Reg. No.: W0183-03

Regulation 10(2)(b)(ii) of the EPA (Industrial Emissions) (Licensing) Regulations 2013, in respect of a licence review from Starrus Eco Holdings Limited for an installation located at Starrus Eco Holdings Limited (Millenium Business Park), Millennium Business Park, Grange, Ballycoolin, Dublin 11, Dublin, D11 PN52

I refer to the Notice in accordance with Regulation 10(2) (b) (ii) dated 6th November 2024. The Agency's queries are set out in italics followed by the Starrus Eco Holdings Ltd (SEHL) responses.

Title
MONITORING LOCATIONS

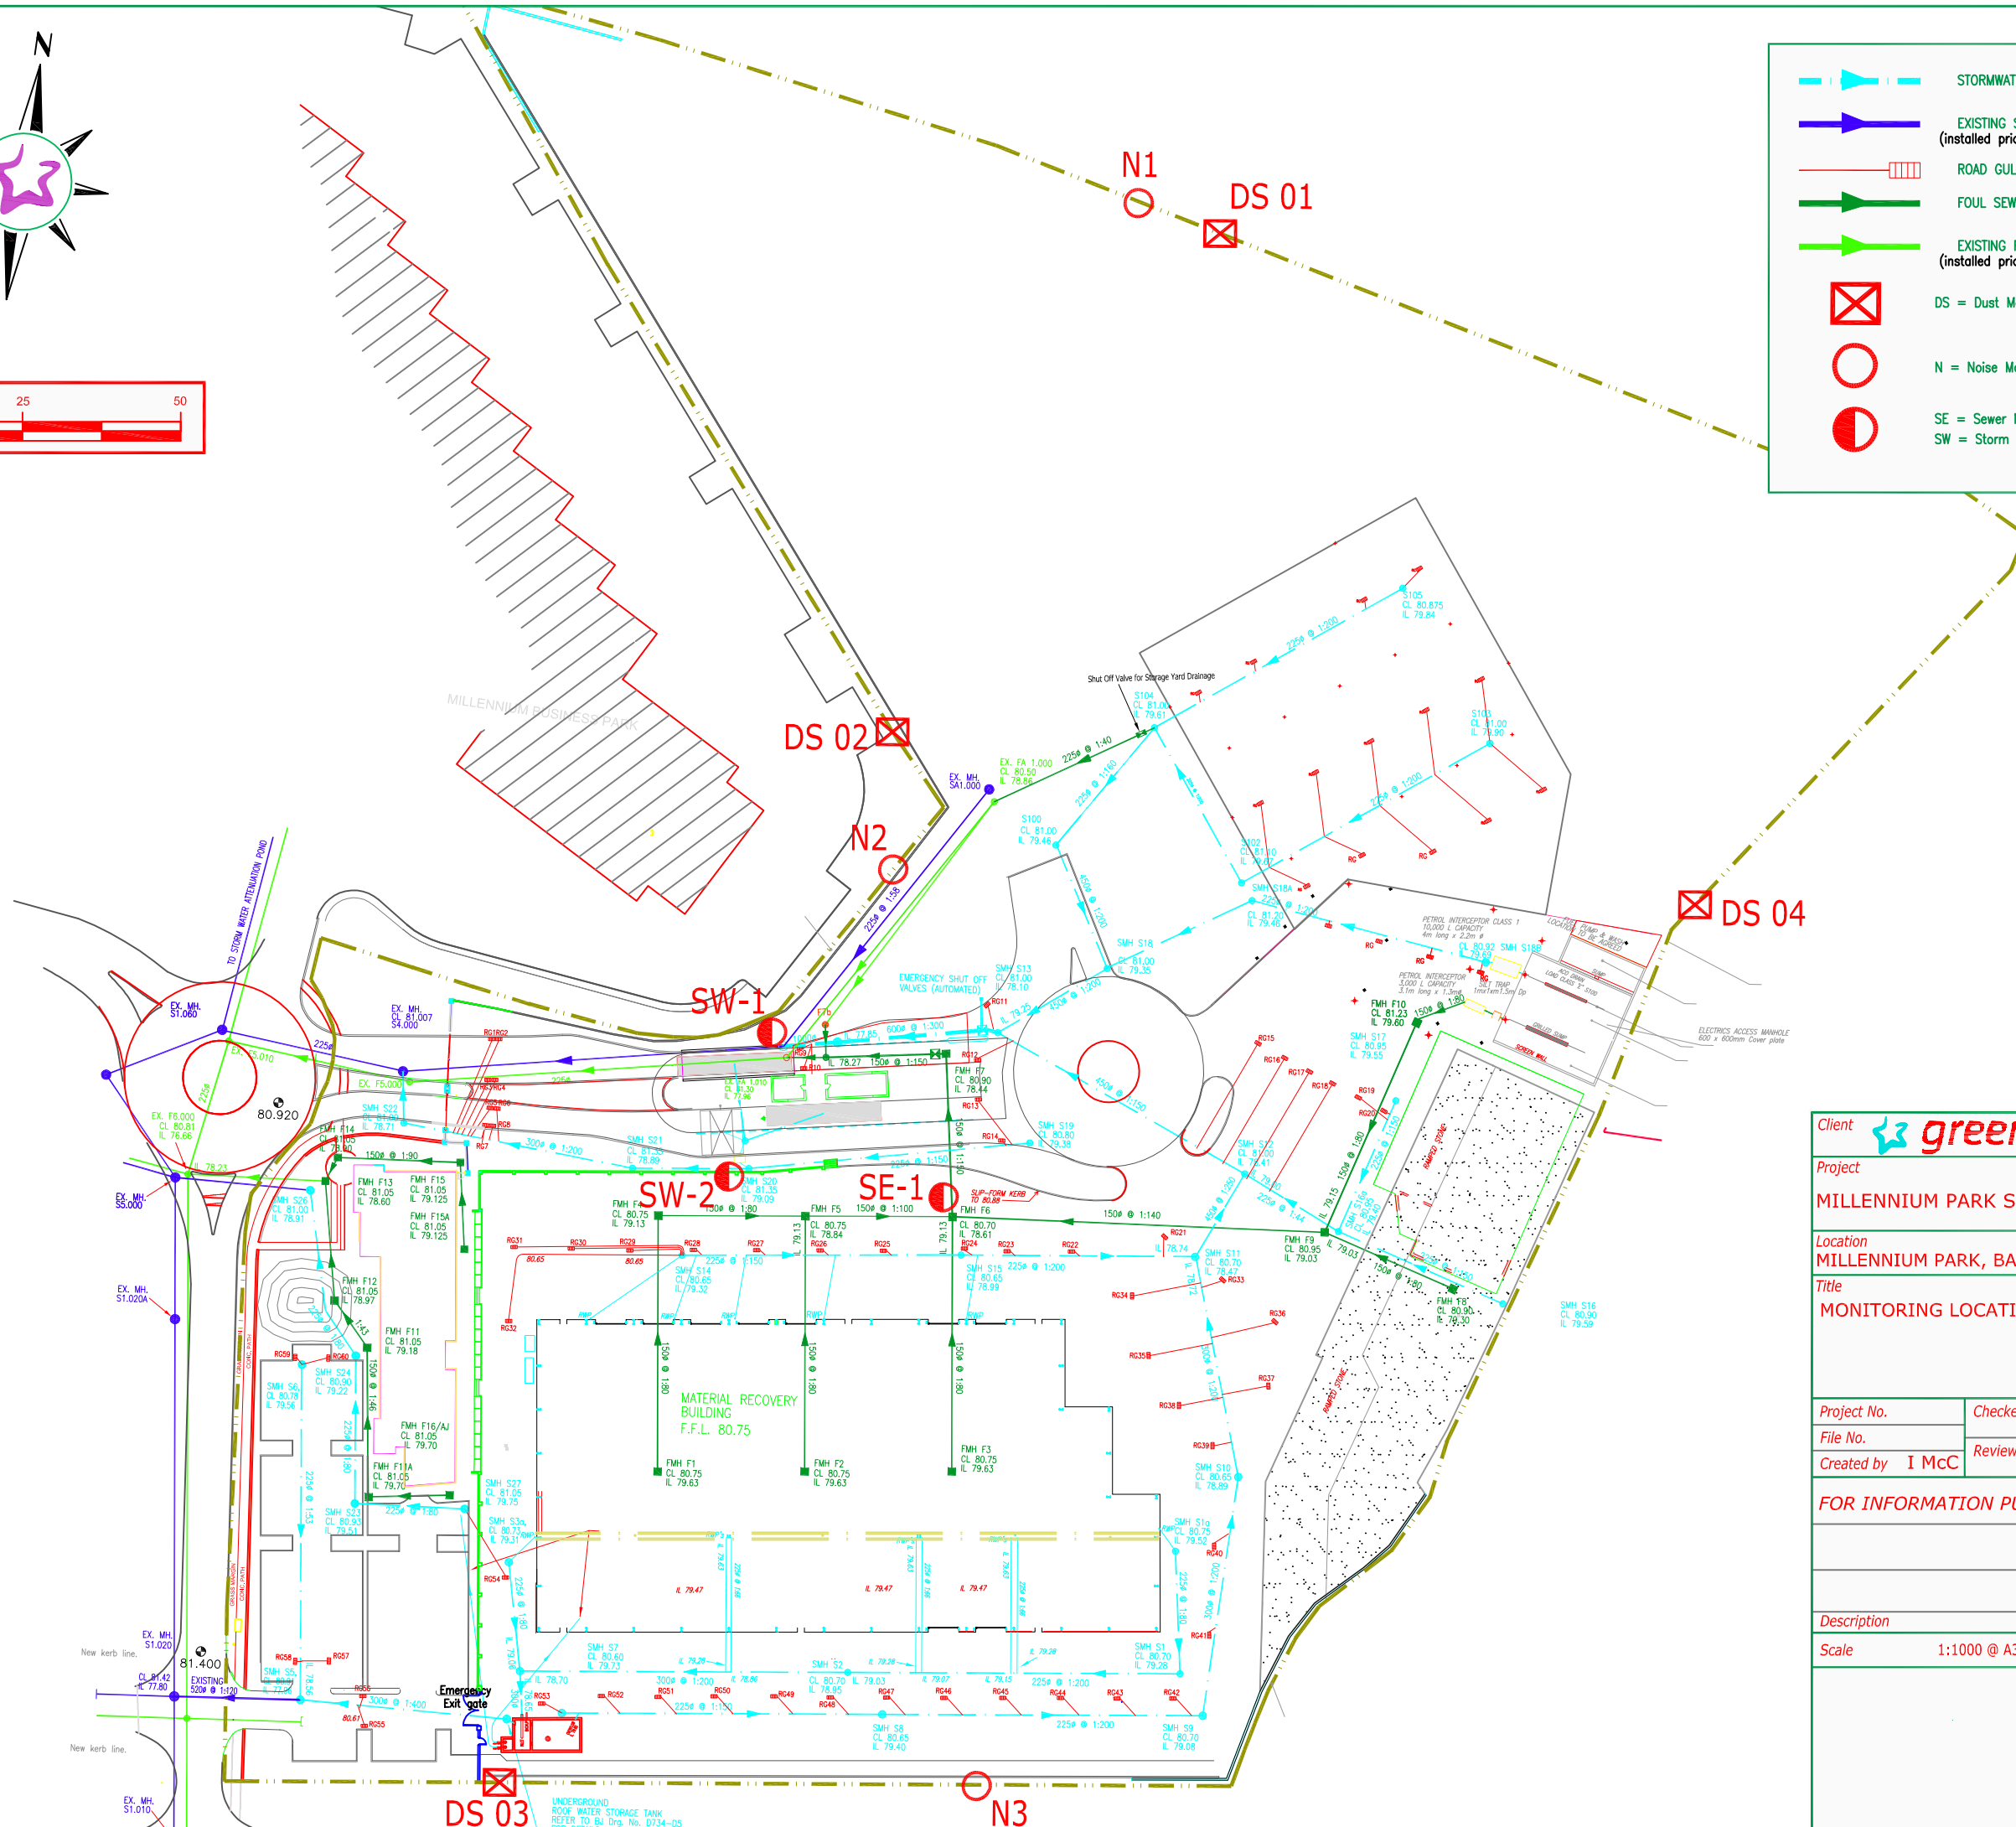
Provide a map of the installation that clearly identifies all the emission points on-site (e.g. storm water, air and dust monitoring locations).

A drawing showing all of the emission points is in Attachment 7.1.2 Emissions Compliance Report included in the licence review application and for clarity is in Attachment C.
